MONTGOMERY COUNTY HISTORIC PRESERVATION COMMISSION
STAFF REPORT

Address:	3 Chevy Chase Circle, Chevy Chase	Meeting Date:	3/25/2026
Resource:	Outstanding Resource Chevy Chase Village Historic District	Report Date:	3/18/2026
Applicant:	John Joy	Public Notice:	3/11/2026
Review:	HAWP	Tax Credit:	Partial
Permit No.:	1150206	Staff:	Devon Murtha
Proposal:	Window replacement

STAFF RECOMMENDATION

Figure 8: South elevation of the Parish house (left) and the plan showing the location of proposed windows highlighted in red (right).

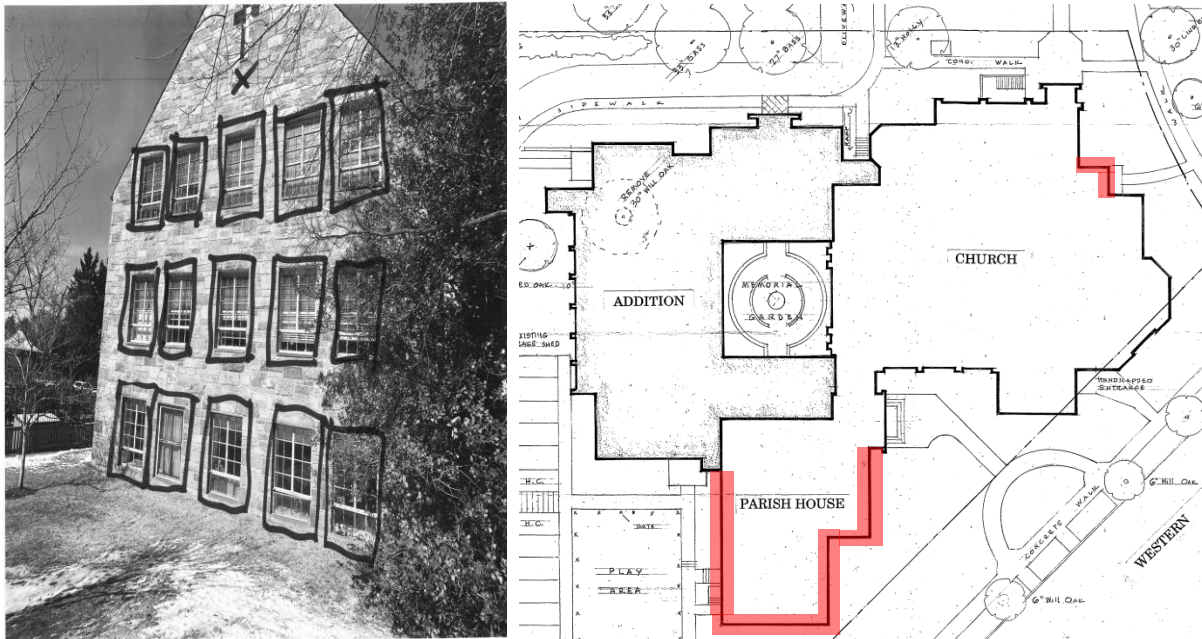
The proposed full-frame aluminum-clad window replacement will be located on the east, south, and west elevation of the 1950s Parish House, and on the 1950s tower (Figure 8). All proposed windows will be visible from the right-of-way along Western Avenue, Oliver Street, and Chevy Chase Circle.

The proposed aluminum-clad casement windows differ from the existing steel casement windows in both texture and profile; however, Staff finds them to be compatible with the resource. Steel windows are difficult to source, and Staff finds that it would be unreasonable to make the applicant install new steel windows on a non-historic addition. The HPC has consistently found that appropriately detailed aluminum-clad windows are compatible replacements for non-historic addition in Chevy Chase Village. The new windows match the old in overall size and appearance and will be installed to closely match the inset depth of the existing windows. The HPC does not typically regulate color, however, Staff notes that the windows may be less conspicuous in a dark color, and recommends that the applicant consider a darker option for these windows.

Figure 9: Existing steel windows on the tower (left); and proposed clad casement windows specifications (right).

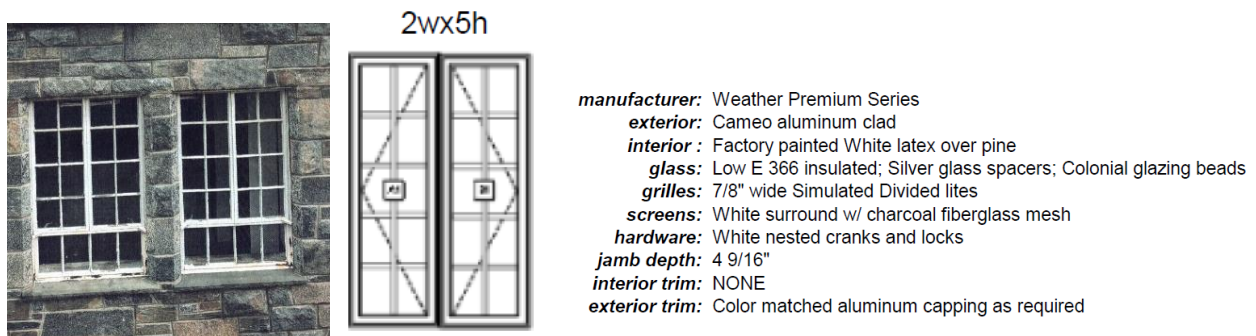
Staff notes that the specifications indicate the presence of “aluminum capping as required.” Staff finds that excessive aluminum capping may have a negative impact on the appearance and compatibility of the windows, and that the applicant must submit updated installation drawings to show the extent of the aluminum capping for Staff to review. Aluminum capping should be minimal to minimize the visual impact from the right-of-way.

1. The applicant will submit final window specification to Staff to confirm window details.
2. The applicant will submit updated installation drawings showing the extent of the aluminum capping.
